Navigated Path: Case CE NAR > HEAVY EQUIPMENT > CRAWLER DOZERS > 1000 > 1150B - CASE CRAWLER TRACTOR (1/73-12/84) > 07 - HYDRAULIC SYSTEM > 360 - R38637 INLET AND OUTLET SECTION >

360

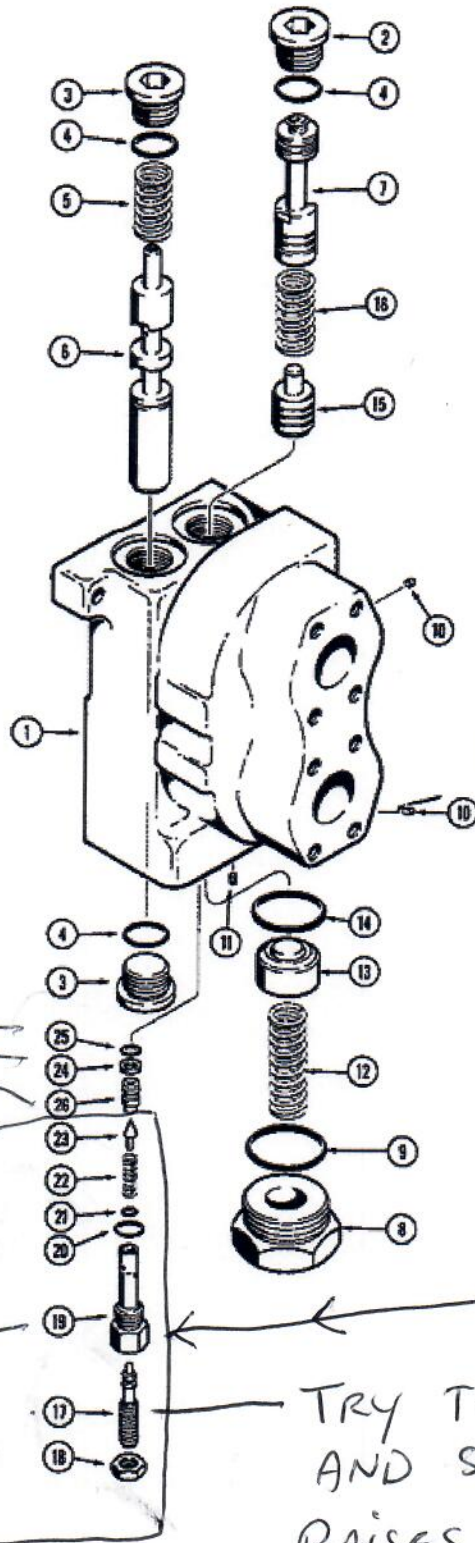
THESE SHOULD  
STAY IN  
UNLESS O-RINGS  
ARE BAD

THIS UNIT  
IS NOT  
AVAILABLE  
AS A UNIT

BE CAREFUL  
NOT TO  
LOOSE ANY  
PARTS THAT  
MAY FALL  
OUT.

TRY TURNING CLOCKWISE  
AND SEE IF PRESSURE  
RAISES - IF NOT - PULL  
RELIEF AT 19
